HYDROLOGY

GRADING & DRAINAGE PLAN
SCALE: 1/8" = 1'-0"

A FOUR-PLEX FOR
MR & MRS. CLYDE MILLIGAN
12 OCT 1978 SHEET 9 of 9 REVISED

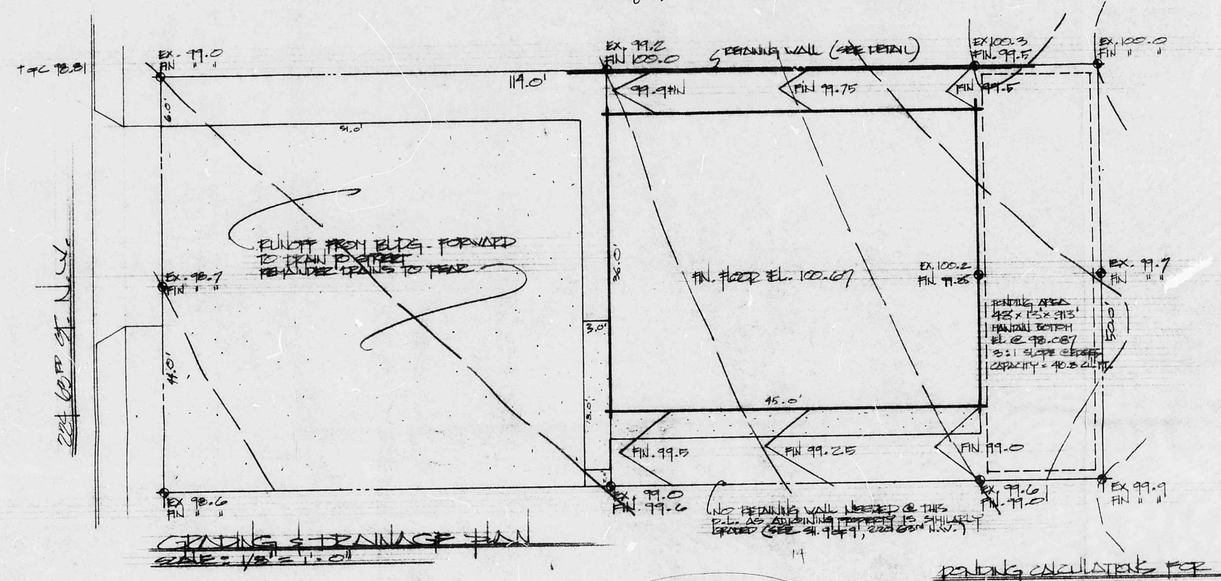
WHERE DOES BLDG DRAIN?
BRUNO
CORRECTED BY ARCHITECT
3 CHANGES ON EAST SIDE ONLY
3/6
